**ADDENDUM NUMBER TWO**  
**Erwin Riverfront Marina Parking Lot**  
**Proposed Paving at Parks Maintenance Building**  
**FOR THE CITY OF CHATTANOOGA, TENNESSEE**  
**Contract Number R-16-015 / R-17-002**

QUESTIONS HAVE BEEN RECEIVED ABOUT THE PAVING AT PARKS MAINTENANCE OFFICE ON MIDDLE STREET

PROPOSED LOT PAVING  
PARKS MAINTENANCE BUILDING  
DUMPSTER CORRAL DETAILS

<b>CONDITIONAL ITEMS</b>					
7	Remove 8 additional inches of existing Min. Agg. Base and subbase (if needed)	1	LS		
8	Remove and Replace poor quality subbase with suitable material, including compaction per specifications	1	LS		
303-01	Min. Agg. Base (8" Min, 33P), placed and compacted	268	TON

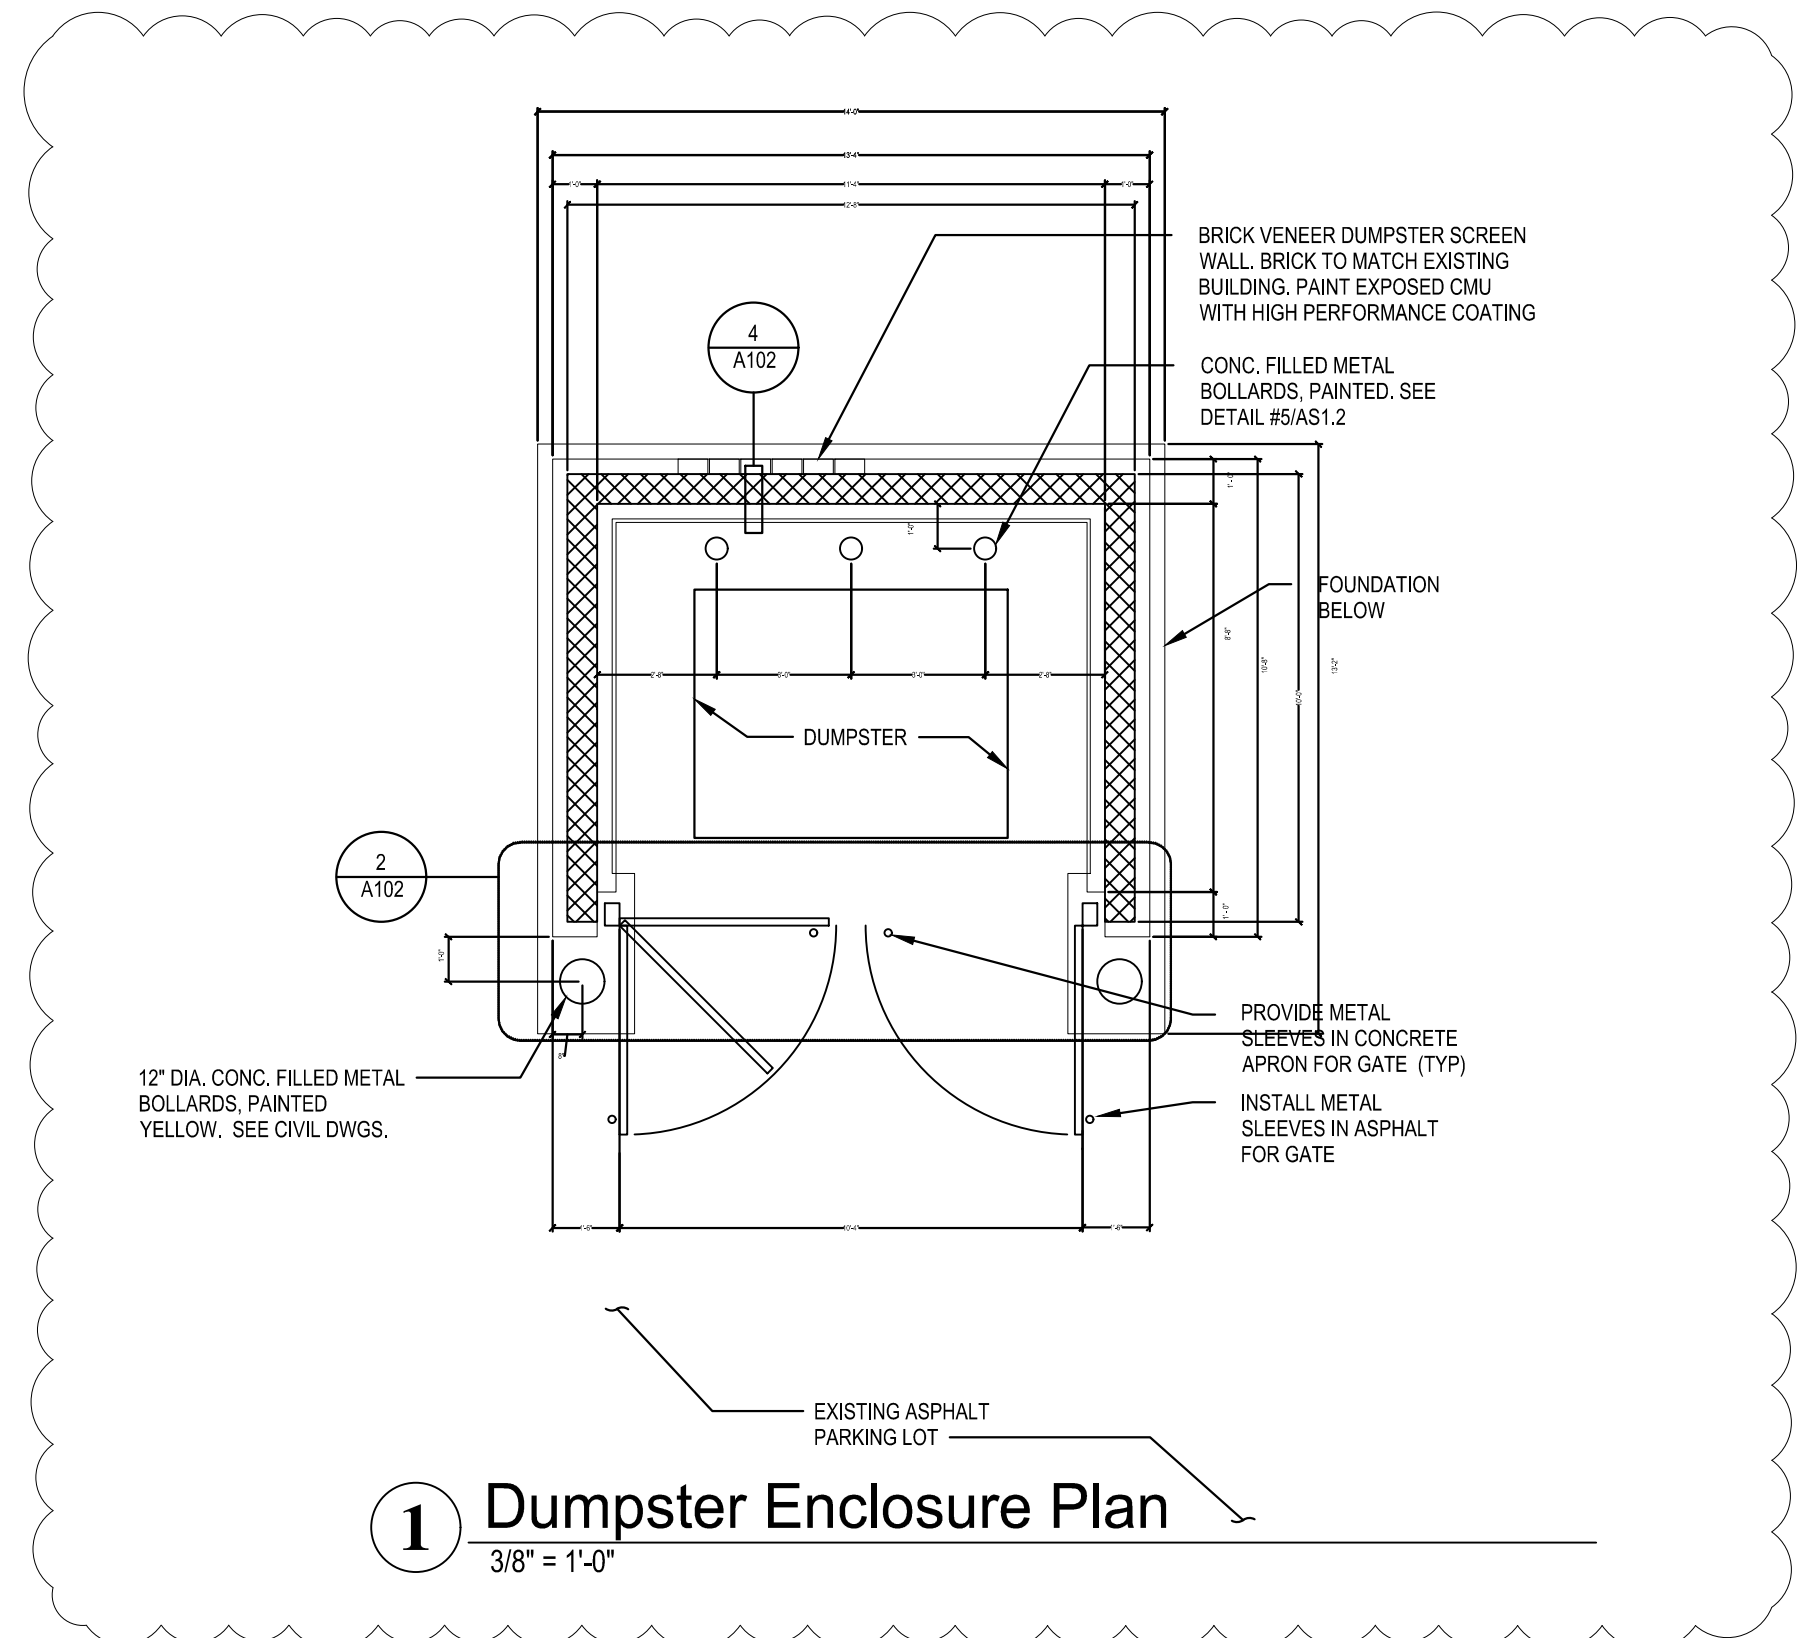
**Q1. Detail 1 on Dumpster Corral drawings: Can we get some dimensions from outside to outside of the block**

A1. Front to back measurement is 10'-0". Width is 12'-8". See attached drawing revision.
